FED. RD. DIV. NO.	PROJECT NO.	SHEET NO.
6		1
STATE	STATE DIST.	COUNTY
TEXAS	SAT	GUADALUPE
CONT.	SECT.	JOB HIGHWAY NO.
0915	46	052 CORDOVA

30% SUBMITTAL

FEDERAL AID PROJECT
 PROJECT NO.
 CSJ: 0915-46-052
 LIMITS FROM: SH 46
 TO: SH 123

FOR WORK CONSISTING OF EXPANDING ROADWAY FROM 2 TO 4 LANES WITH RAISED MEDIAN OR CENTER TURN LANE. REALIGN CORDOVA ROAD AT SH 46. ADD SHARED USE PATHS.

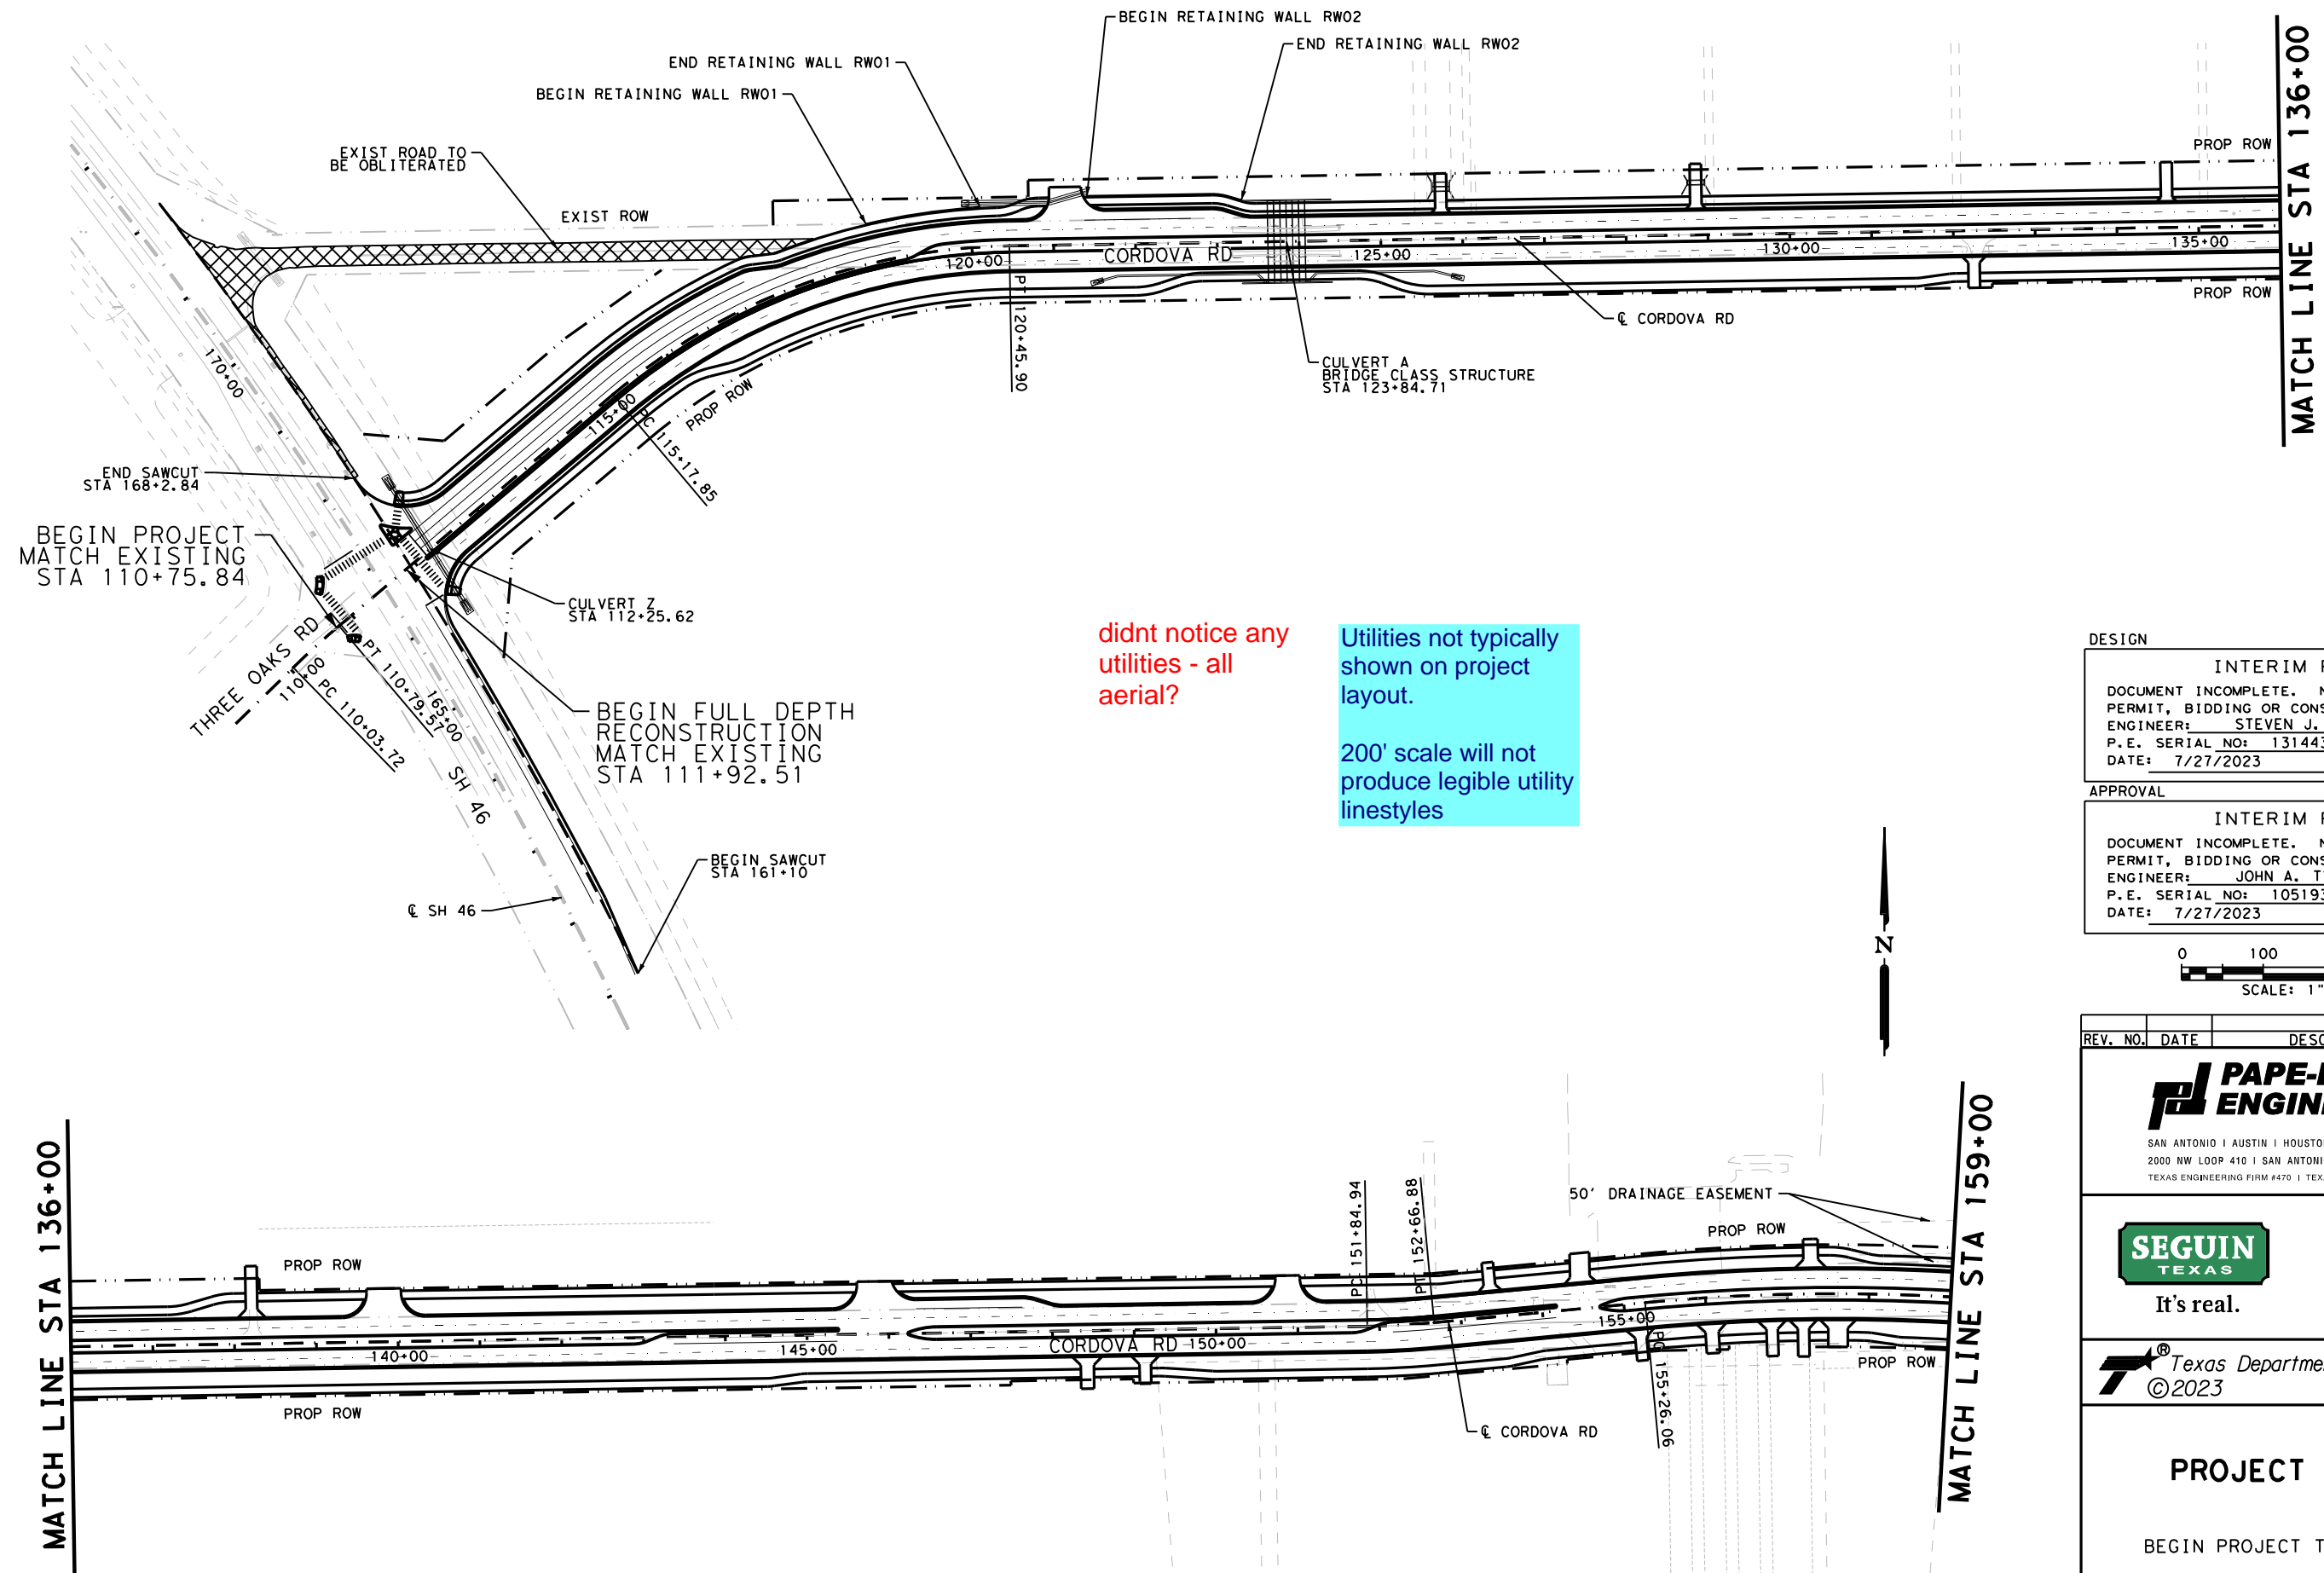
didn't notice any utilities - all aerial?

PROJECT LAYOUT
STA 271+00 TO END OF PROJECT
SHEET 5 OF 5

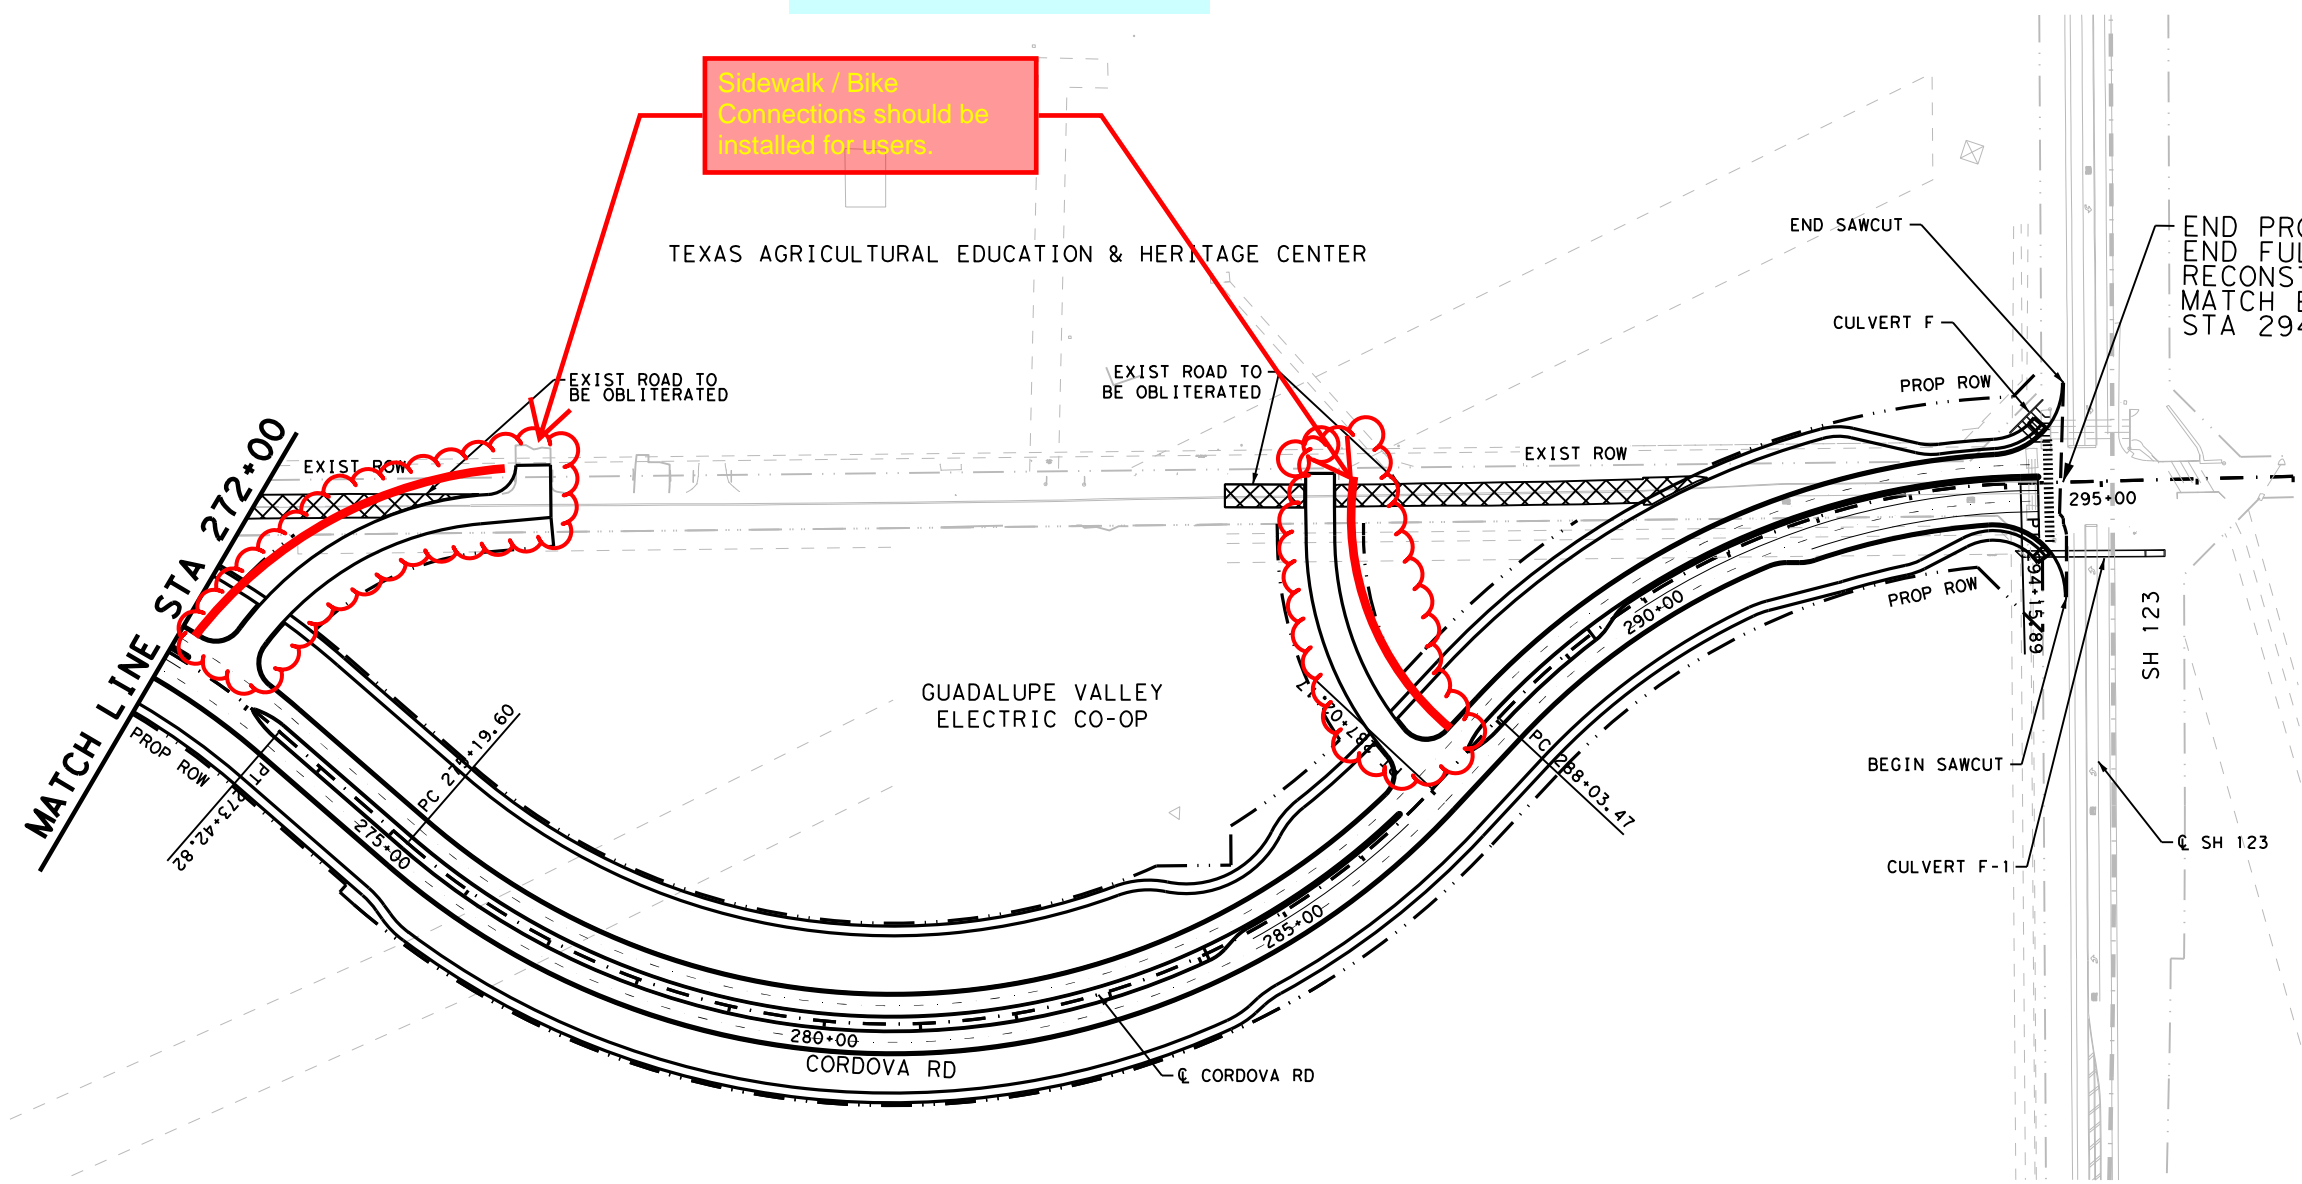
Sidewalk / Bike Connections should be installed for users.

agree, work on coordination with property owners

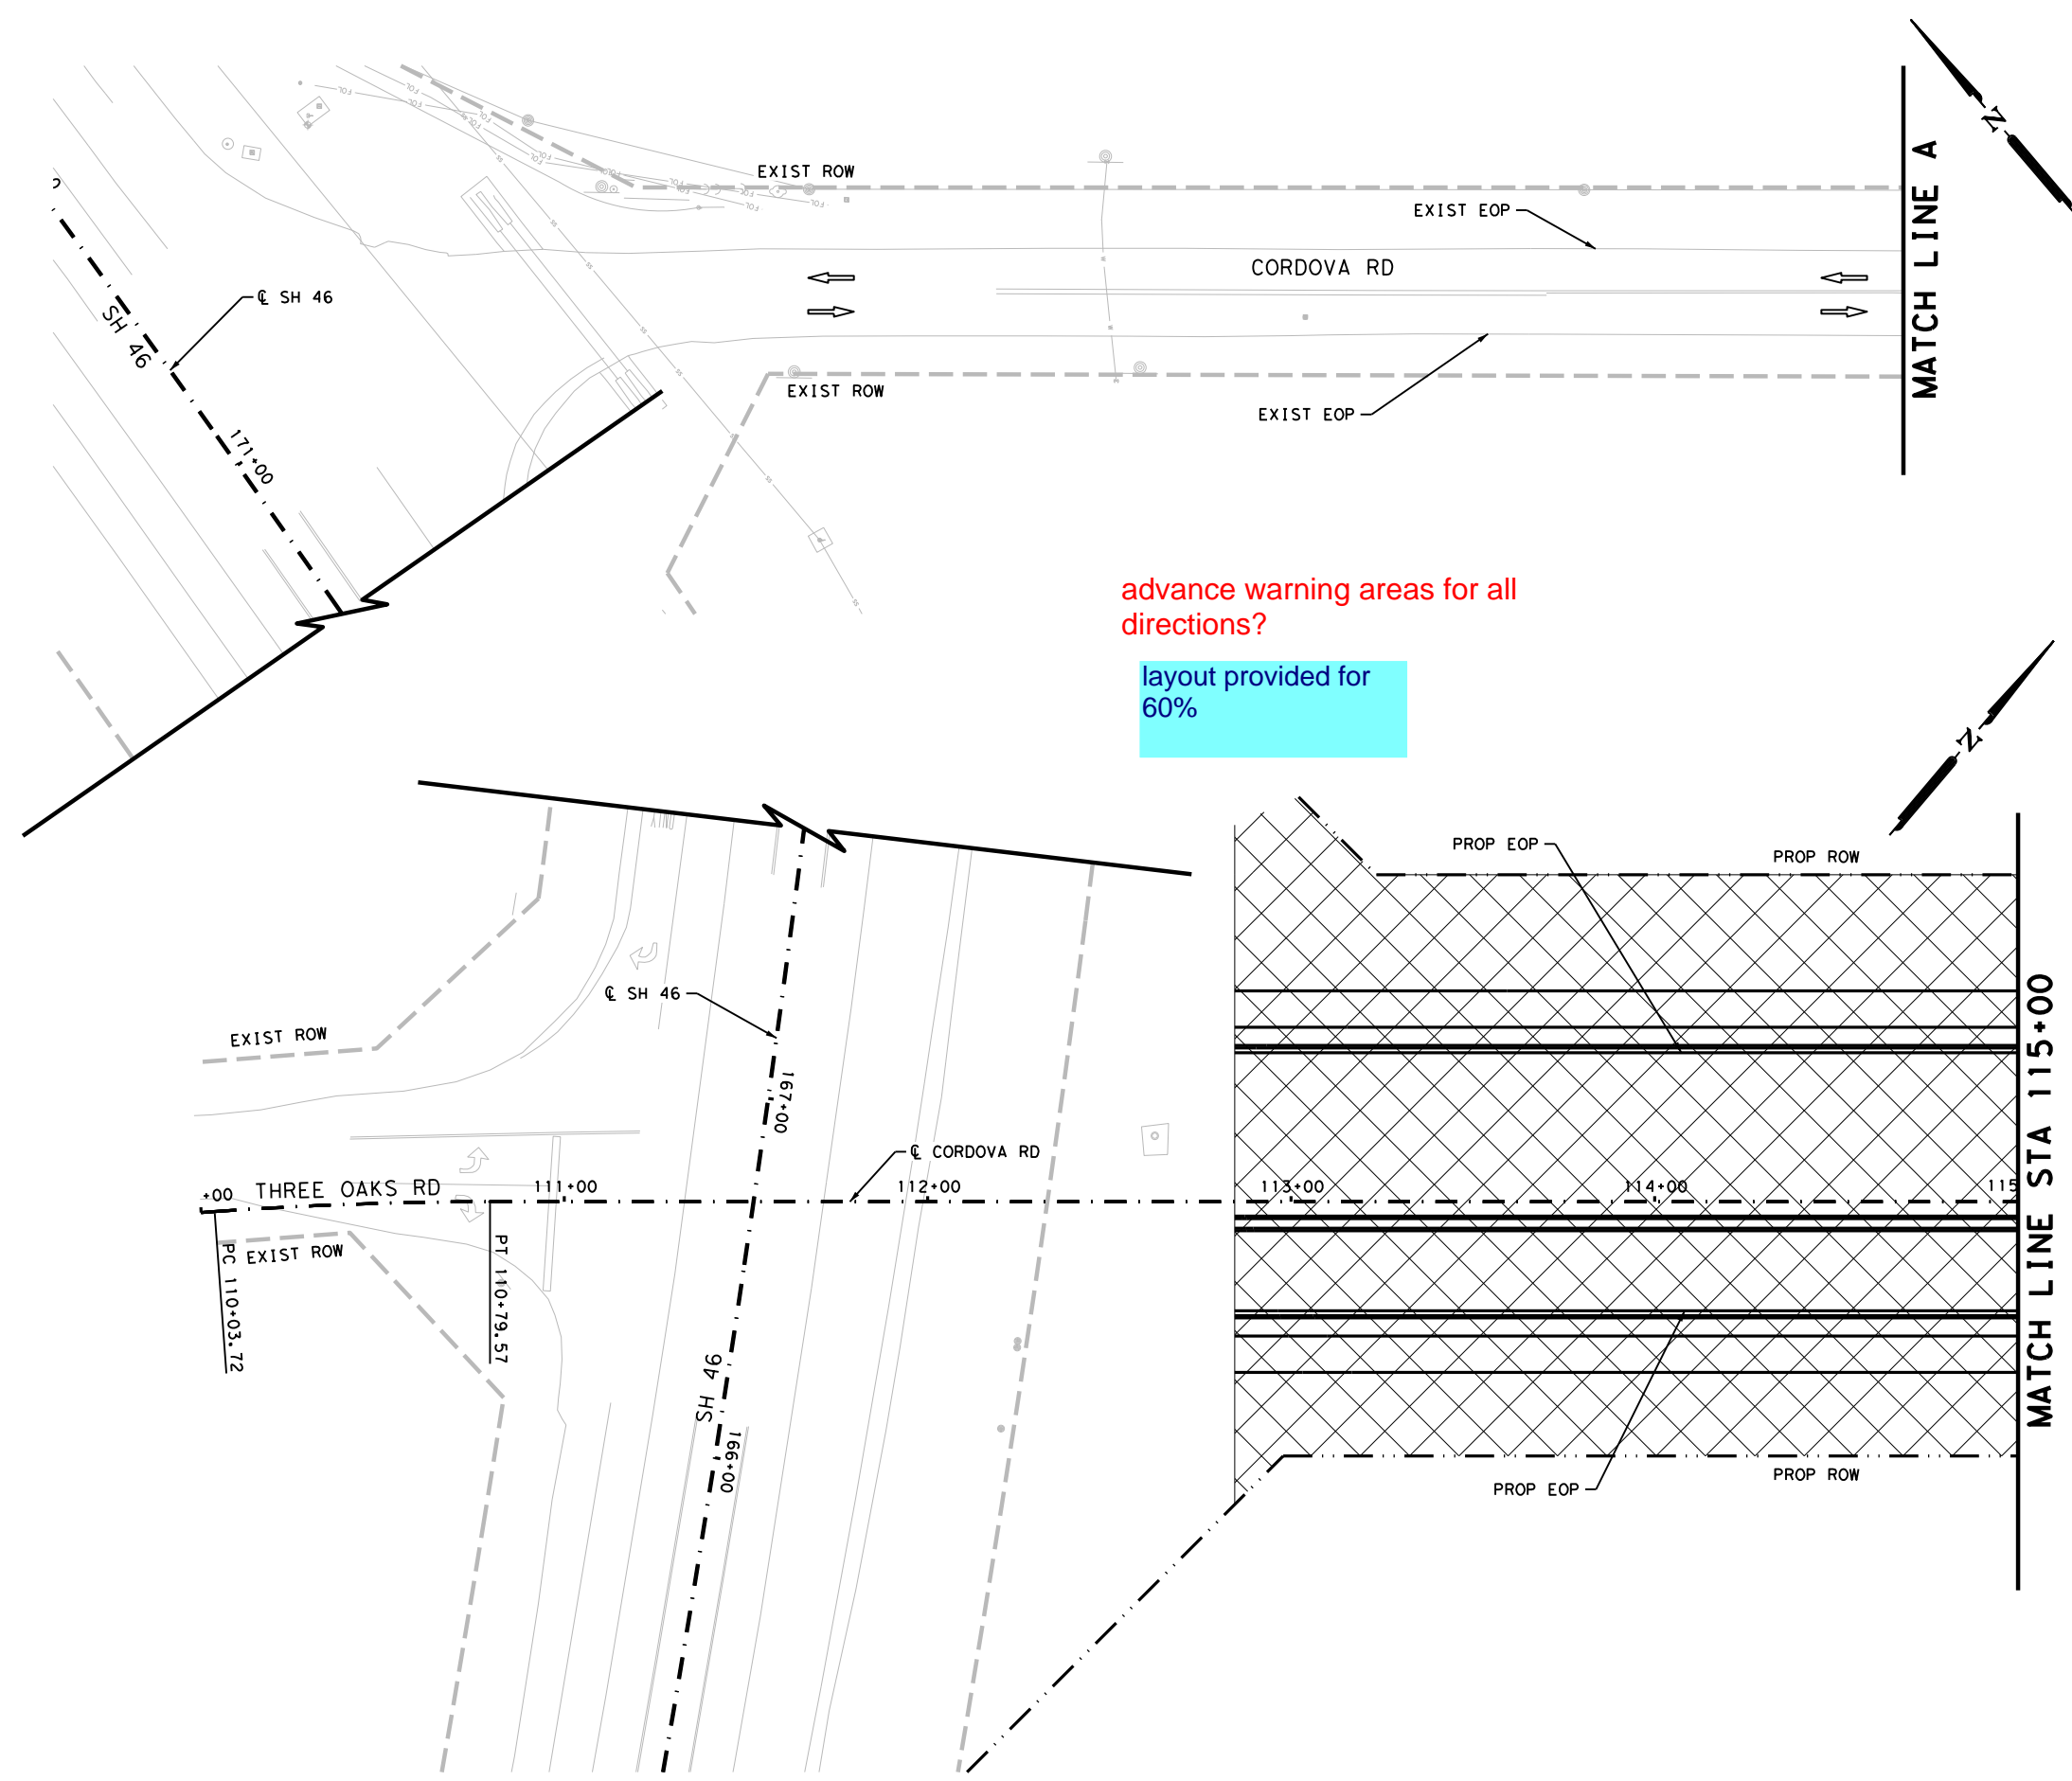
advance warning areas for all directions?
